RFI RESPONSE

REG. REF. LRD22A/0930

Dalguise House, Monkstown, Dublin 16, Dún Laoghaire Rathdown

Communal Amenity Spaces- Communal Gardens

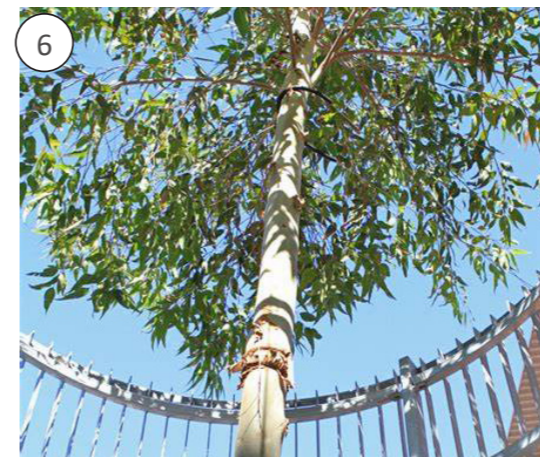
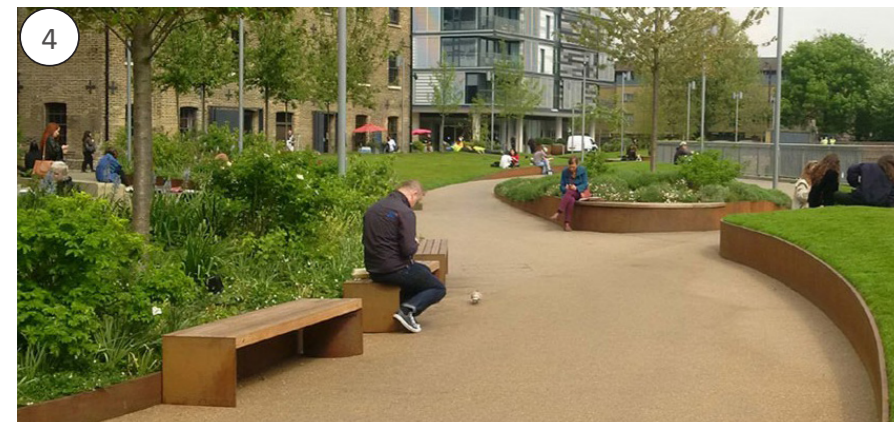
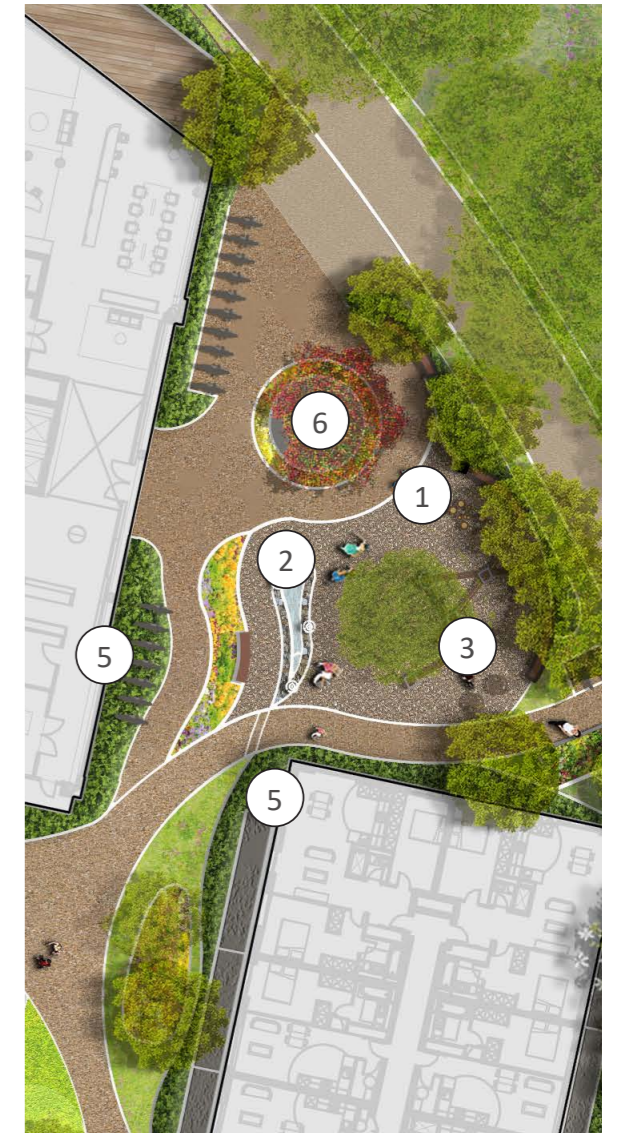
“..The Applicant is requested to submit a design rationale to the usability and functionality of these spaces having regard to the design modifications requested previously.”

These garden areas provide opportunities for residents to relax and play in a more enclosed environment. They are in the immediate vicinity of the buildings and therefore include defensible planting, community resting and relaxation spaces in addition to dedicated play areas. There is an extension of the serpentine paths that unite the site with a smaller, more human scale landscape. Nature play has been enhanced in these gardens with water play features

In the northeast garden area there will be a feature tree coming up from the basement with a balustrade and ornamental planting around it.

Example of a Typical No-Dig Detail:

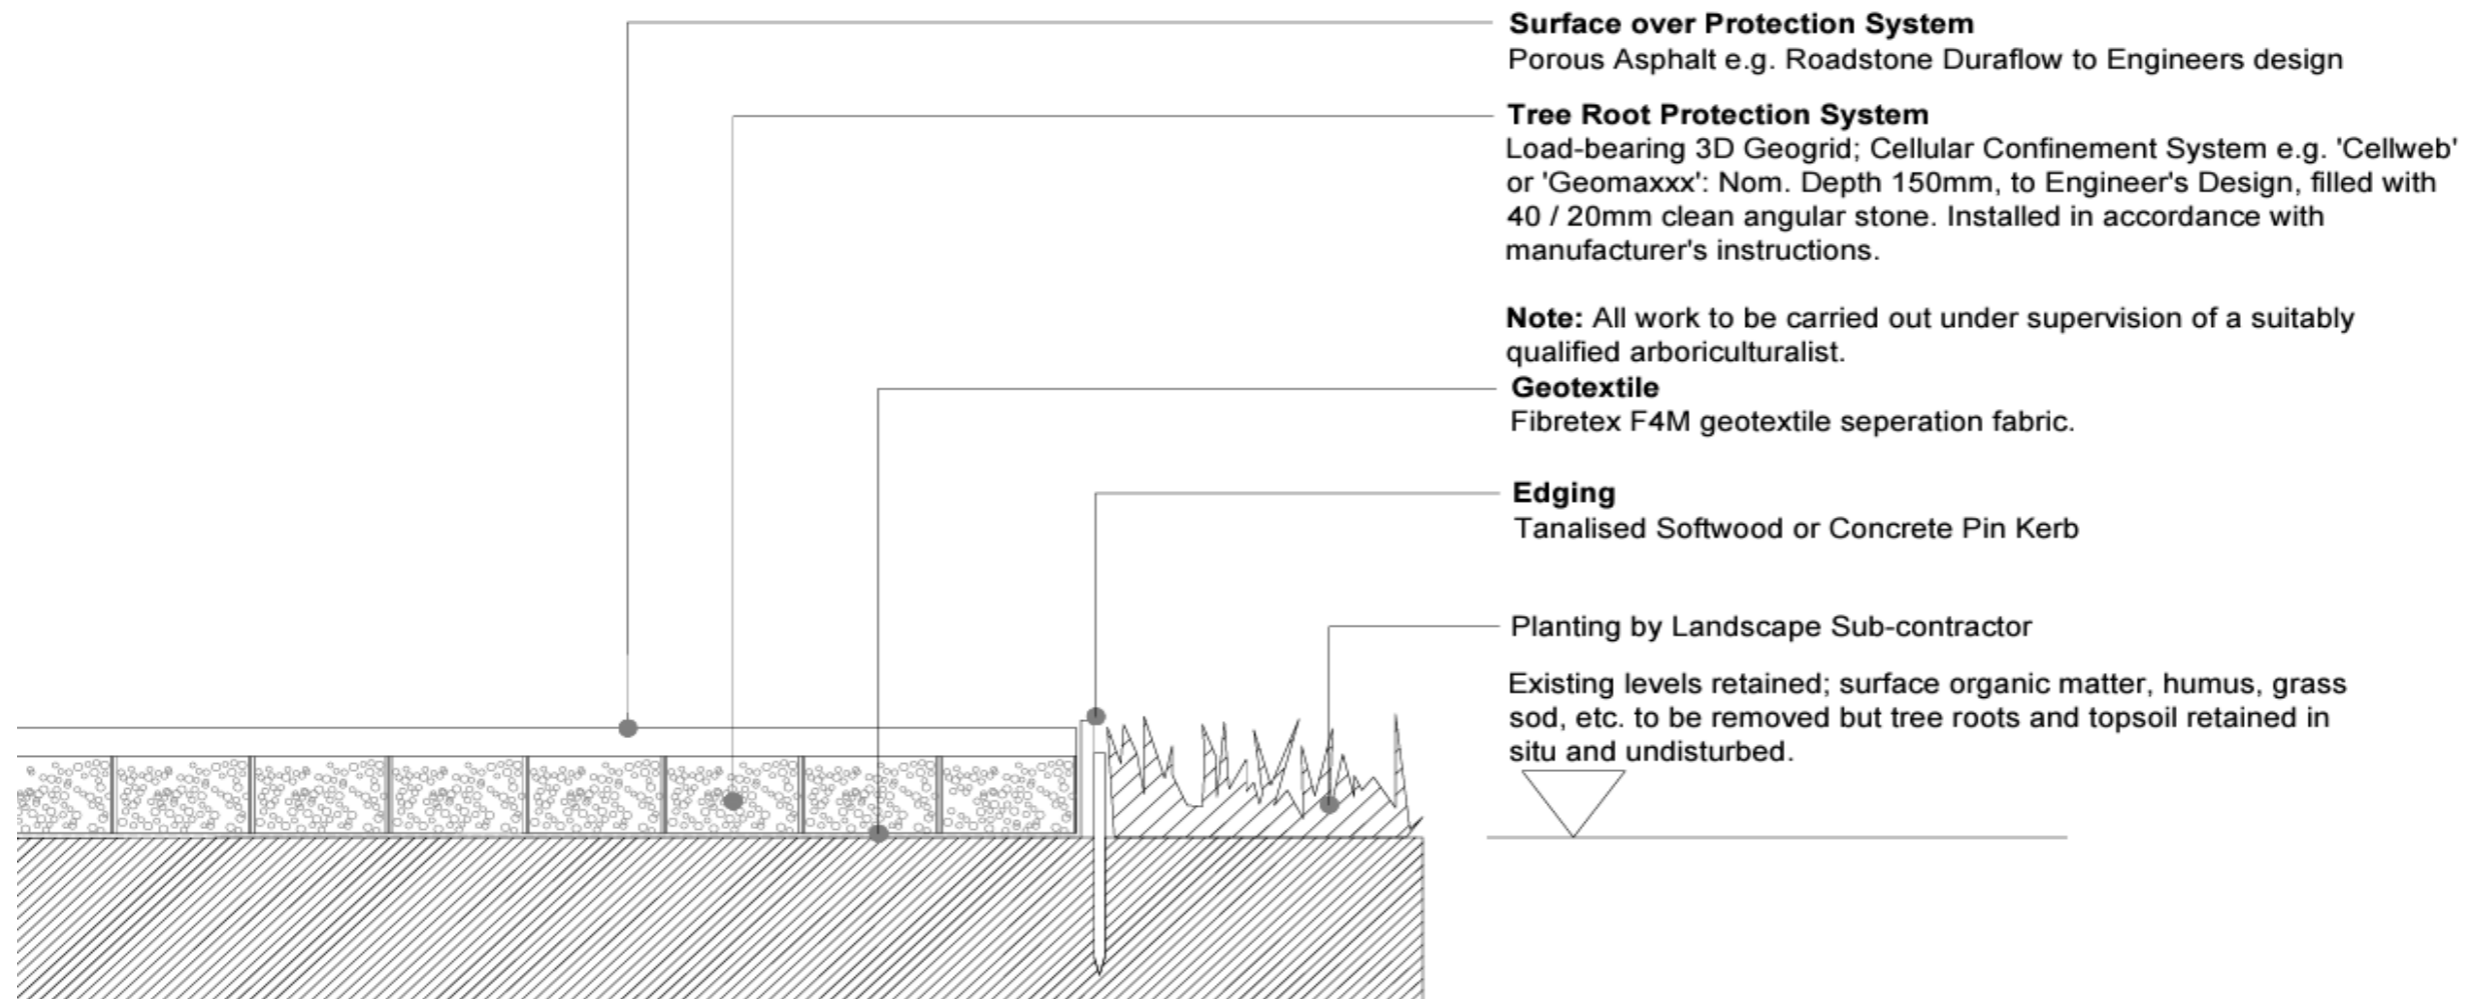
... c. The provision of Bark Chips on pedestrian routes is not suitable and will exclude users of various abilities. Proposed 1.2m access routes should be increased to a minimum of 2m...”

BREAKDOWN RFI	RESPONSE
c. The provision of Bark Chips on pedestrian routes is not suitable and will exclude users of various abilities. Proposed 1.2m access routes should be increased to a minimum of 2m.	<p>Bark chip has been replaced with permeable resin bound surfacing on a no dig detail.</p> <p>A typical no dig detail can be seen on pg. 27</p> <p>Please see the enclosed landscape GA for all surfaces and path layouts, and Landscape access diagram for all accessible routes:</p> <ul style="list-style-type: none"> • C0135 L301 Landscape General Arrangement Ground Floor - Combined Plan • C0135 L9001 Pedestrian Access Strategy

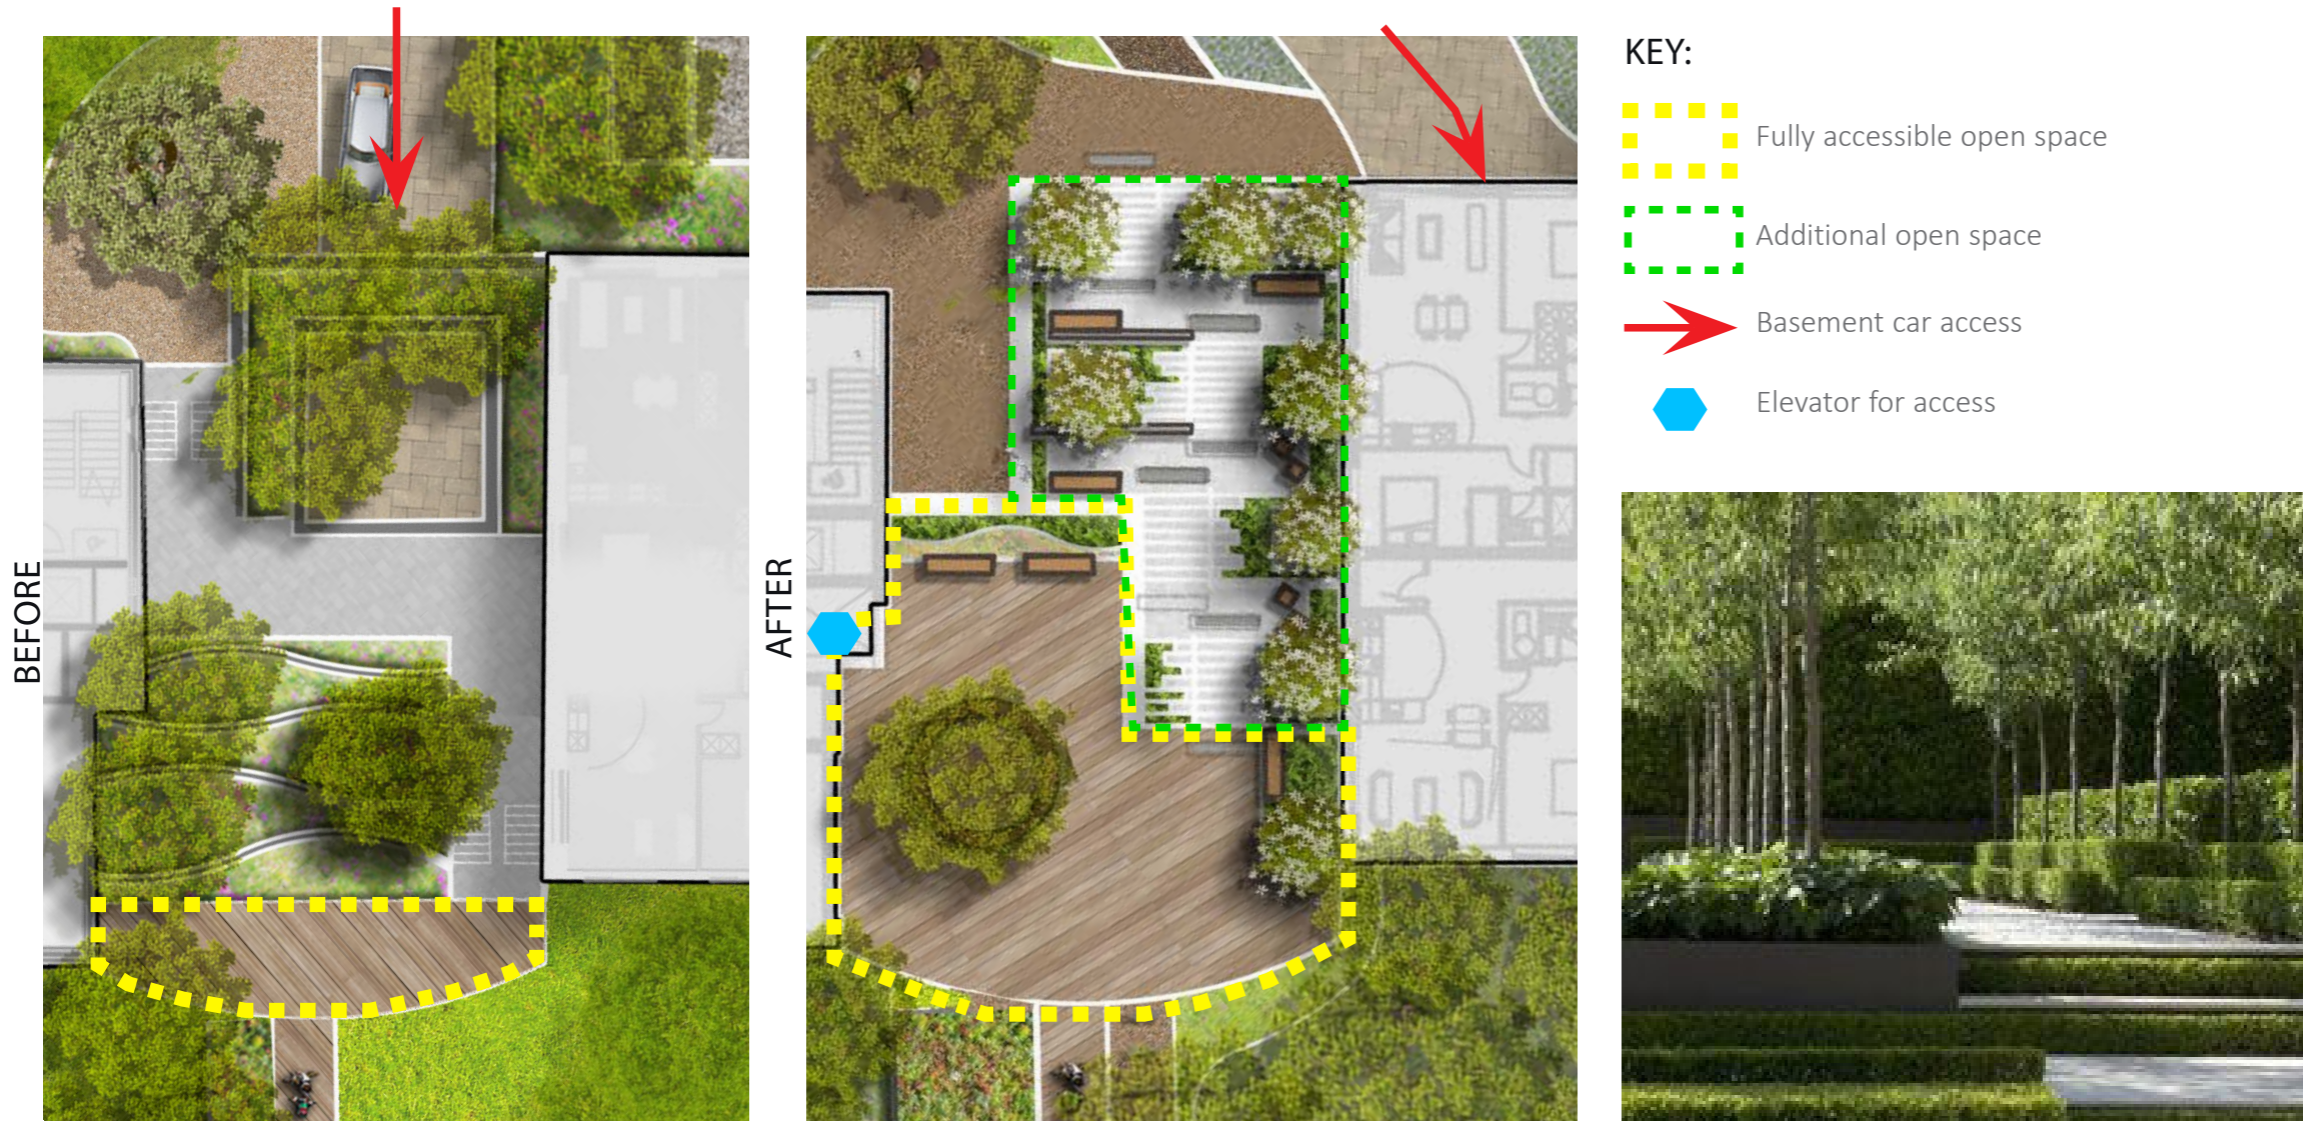
... e. Pedestrian Access to Block B & C requires the use of stepped pathways, or an alternative, more onerous route from the existing vehicular avenue or along the proposed grass-crete emergency access route which is not suitable for all users...”

Realignment of the basement has allowed for a pedestrian centric entrance to the site. Pushing the vehicular entrance under the building opened up space for a feature stairs with amenity resting points and seating nooks. This arrangement has also allowed for the elevator access to be opened up to the external landscape creating a more intuitive route for universal access to a now larger accessible amenity space has now been created at the entrance level between blocks A and B.

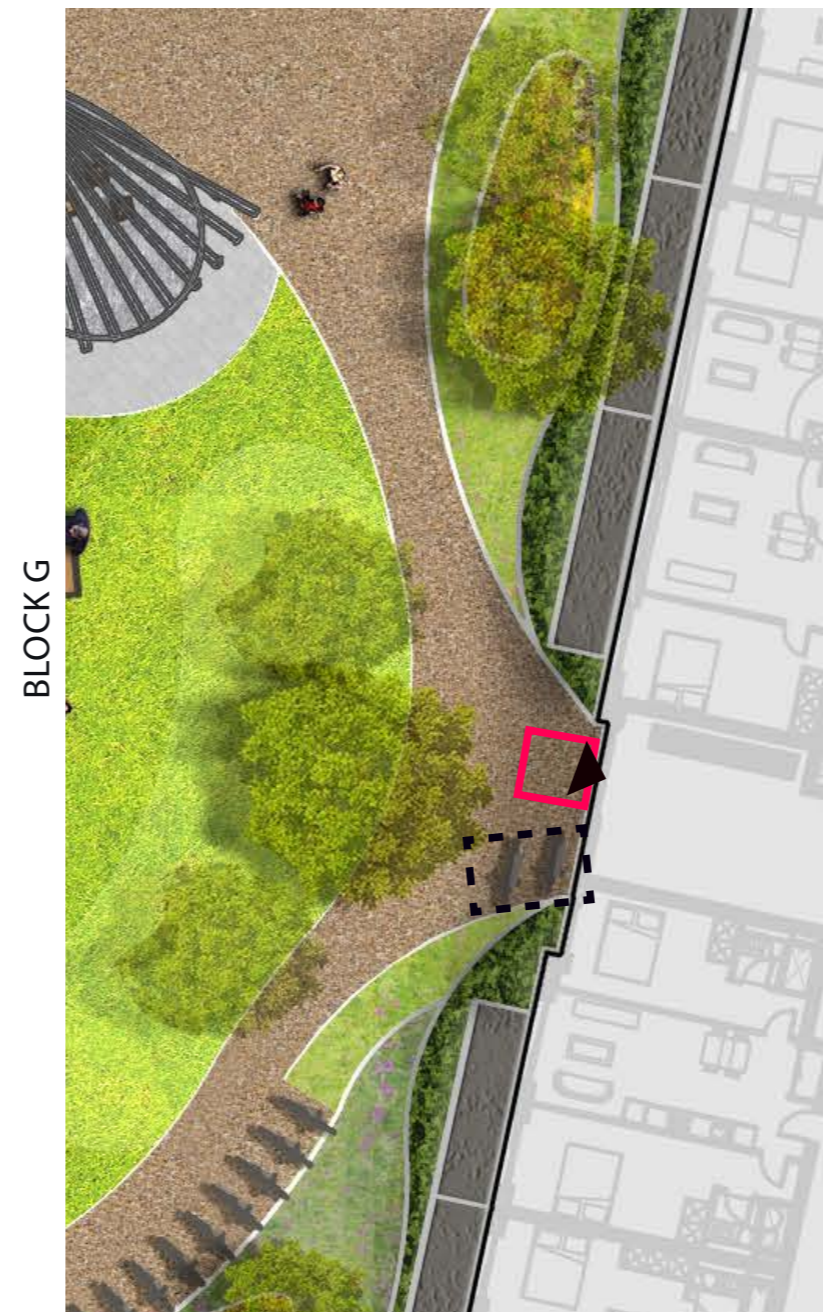
... f. Proposed cycle parking partially obstructs the pedestrian access to Block F & G. ...”

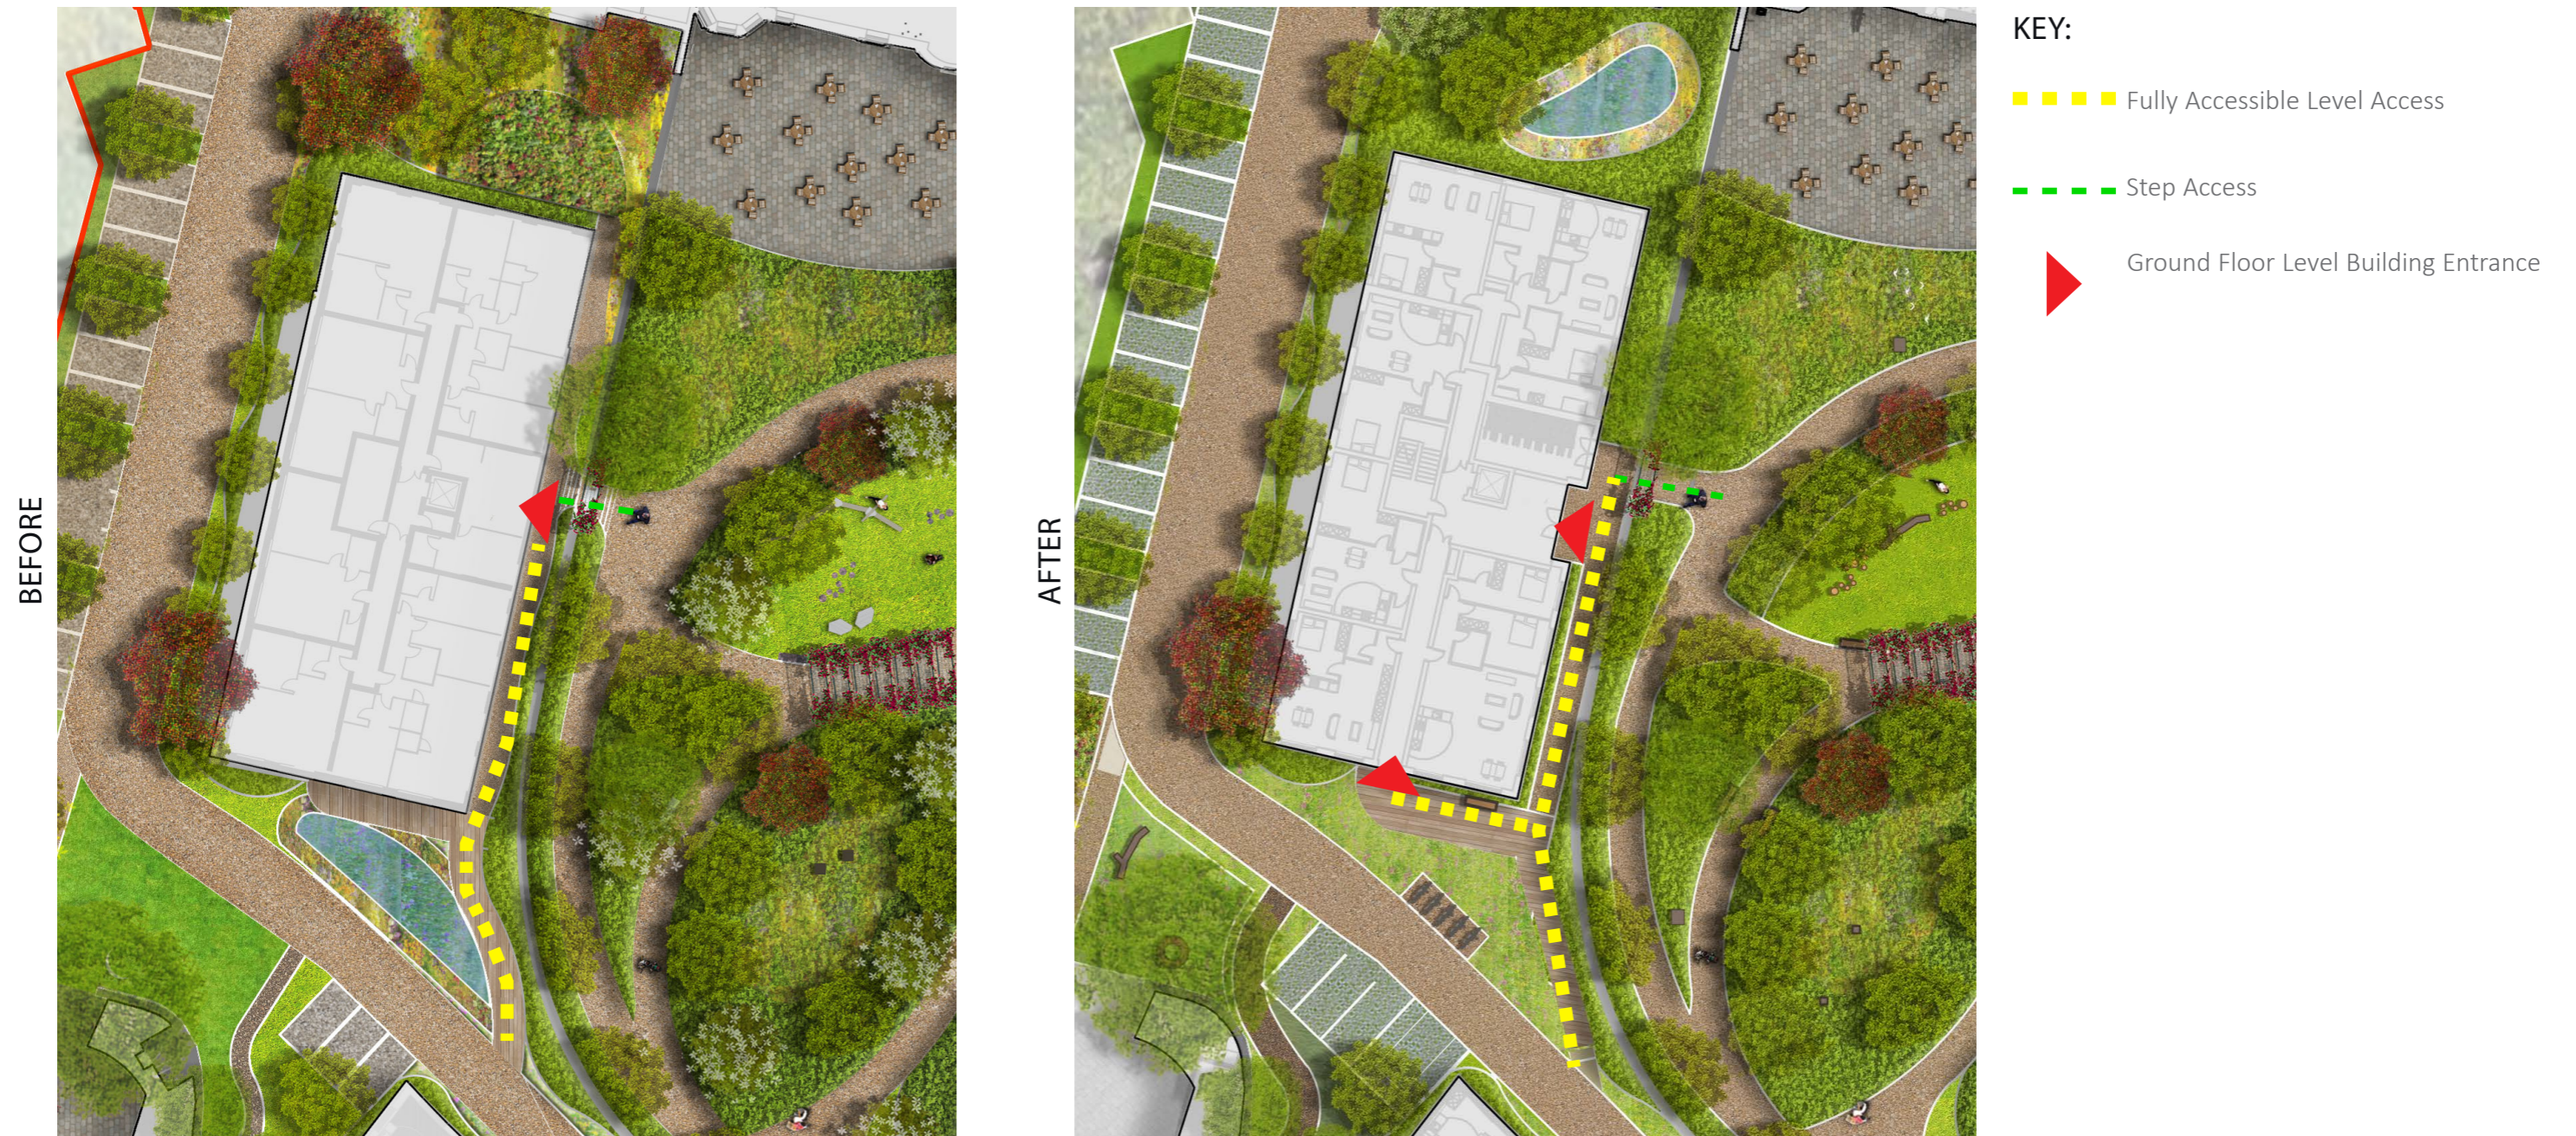
... g. Pedestrian access to Block J includes stepped access. The alternative inclined boardwalk access from the rear of the site is noted, however, an alternative access adjacent to the main entrance should be provided. ...”

g. Pedestrian access to Block J includes stepped access. The alternative inclined boardwalk access from the rear of the site is noted, however, an alternative access adjacent to the main entrance should be provided.	<p>A second GF building entrance has now been provided, access via boardwalk is the primary entrance as it approached the door at level. The second building entrance adjacent to the stepped access through the walled garden has been provided as a secondary access point. In order to provide ramp alongside the secondary stepped access to the walled garden a large amount of the existing wall would need to be removed compromising the original character and design intent. A ramp would also have impact on a mature grade A tree which is marked for retention in this area. Both building entrances are accessible Via the level boardwalk.</p> <p>Please see pg. 28 for breakdown of Plan.</p>
